Device	XMC1300
Marking/Step	EES-AB, ES-AB, AB
Package	PG-TSSOP-16/38, PG-VQFN-24/40

Overview

This “Errata Sheet” describes product deviations with respect to the user documentation listed below.

Figure 1 Clock Selection Diagram for CCU4/CCU8

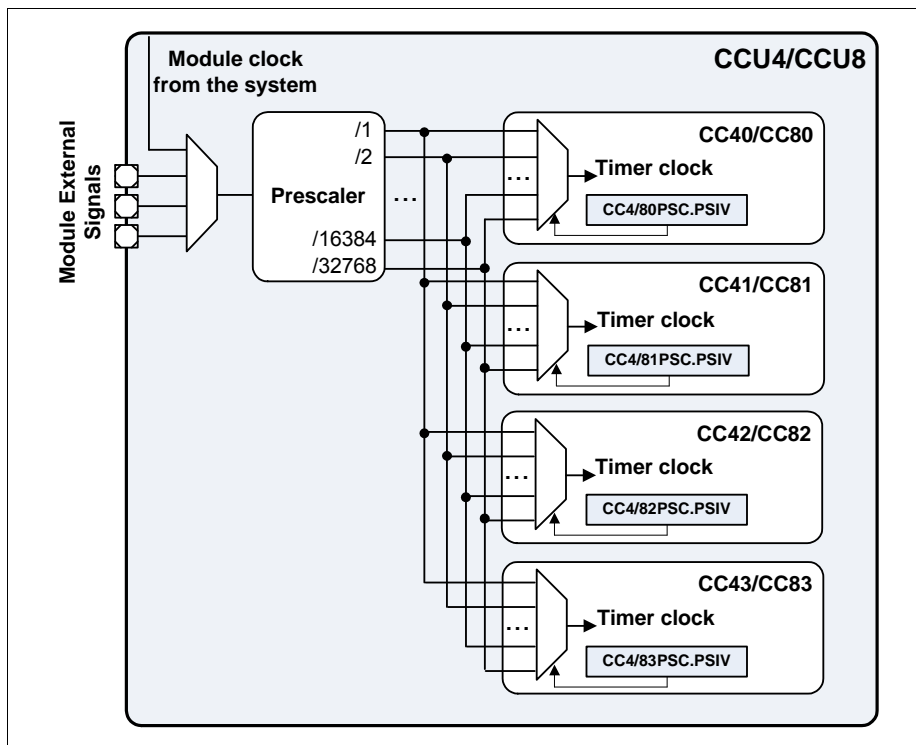
Each CCU4/CCU8 module offers the possibility of selecting an external signal to be used as the master clock for every timer inside the module Figure 1. External signal in this context is understood as a signal connected to other module/IP or connected to the device ports.

Currently is only possible to use an external signal as Timer Clock when a division ratio of 2 or higher is selected. When no division is selected (divided by 1), the external signal cannot be used.

The user must program the PSIV field of each Timer Slice with a value different from 0000_B - minimum division value is /2.

Figure 2 Parity Checker diagram

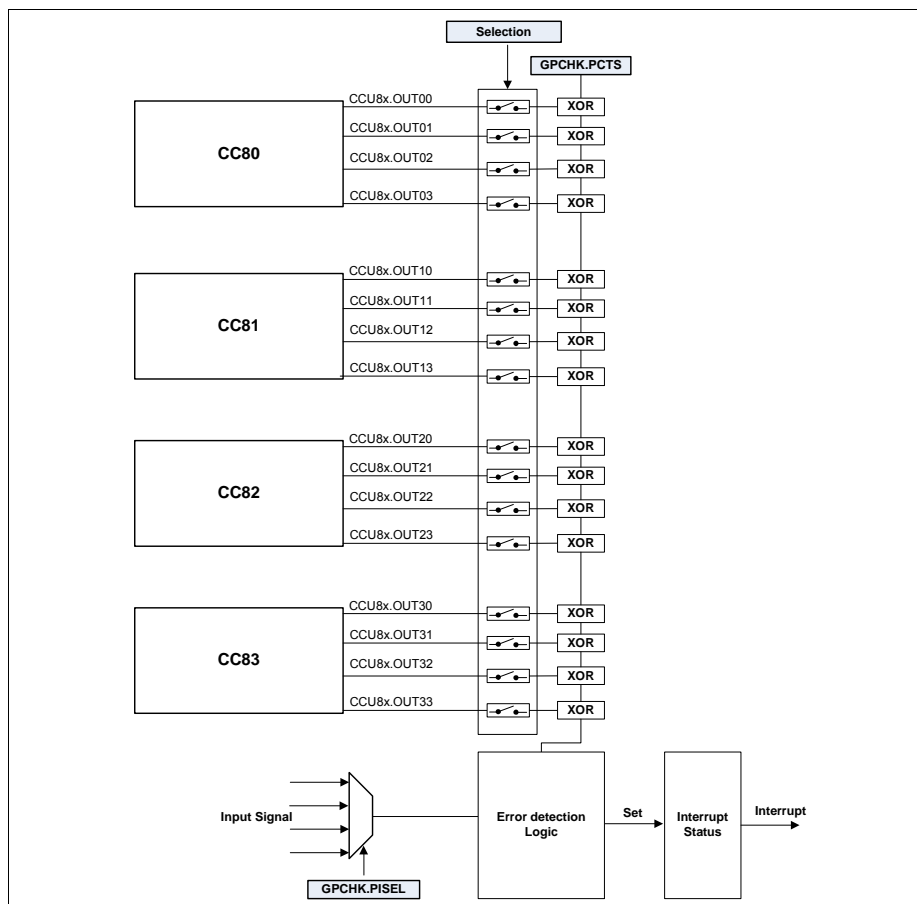
Each CCU8 module also contains a function called Parity Checker. This Parity Checker function, crosschecks the output of a XOR structure versus an input signal, as seen in Figure 1.

When using the parity checker function, the associated status bitfield, is cleared automatically by hardware in the next PWM cycle whenever an error is not present.

This means that if in the previous PWM cycle an error was detected and one interrupt was triggered, the software needs to read back the status register before the end of the immediately next PWM cycle.

Not ORing the Parity Checker error interrupt with any other interrupt source. With this approach, the software does not need to read back the status information to understand what was the origin of the interrupt - because there is only one source.

Figure 4 Different index signal types

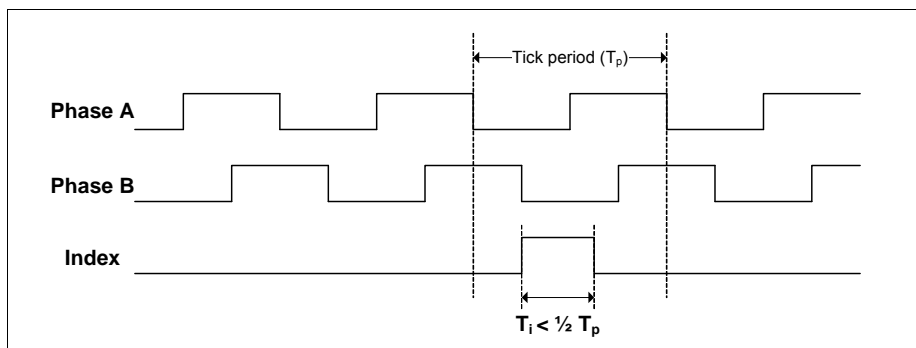
When the index signal is smaller than 1/2 of the tick period, the POSIF module is not able to decode this signal properly, Figure 2 - notice that the reference edge of the index generation in this figure is the falling of Phase B, nevertheless this is an example and depending on the encoder type, this edge may be one of the other three.

Due to this fact it is not possible to use the POSIF to decode these type of signals (index with duration below 1/2 of the tick period).

Figure 5 Index usage workaround - a) Non working solution; b) Working solution

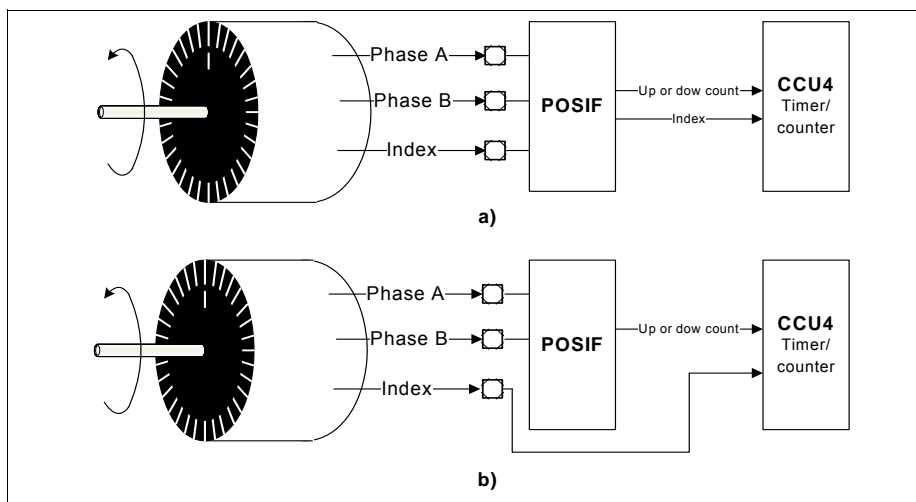
To make usage of the Index signal, when the length of this signal is less than $\frac{1}{2}$ of the tick period, one should connect it directly to the specific counter/timer. This connection should be done at port level of the device (e.g. connecting the device port to the specific Timer/Counter(s)), Figure 3.
